NORTH ANNA #1 STEAM GENERATOR
ROW 9 COLUMN 51
TUBE FAILURE ANALYSIS

October 19, 1987

Final Report

Figure 1

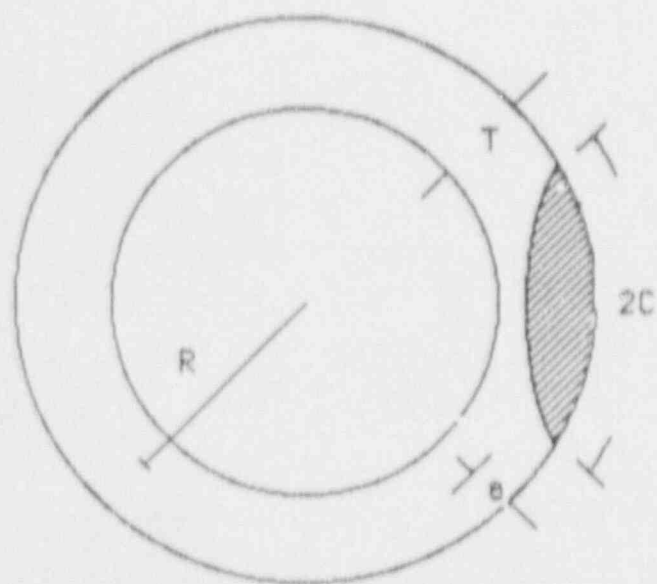
Parks and Chen have recently completed K calculations for a thin wall tube with a thumbnail crack initiating from the exterior which, at least for very small crack depths, reasonably represents our conditions. Figure 1 shows a schematic of the tube and Figure 2 shows the crack geometry. Figure 3 shows the K solution as a function of crack parameters for various crack depths. The solutions for K do not include effects of bending so the solution is only applicable for very shallow crack depths where the axial stress gradient is small. Figure 4 shows the solution for K_{max} ($\phi/(\pi/2) = 1$) as a function of depth. If we extrapolate back to a depth of $0.0025''$ ($a/t = 0.05$) a far field stress of 57 KSI is calculated if one assumes an initial K_{max} of $4 \text{ KSI} \sqrt{\text{in}}$. This stress is consistent with the contention that yield conditions existed in the surface region prior to initiation.
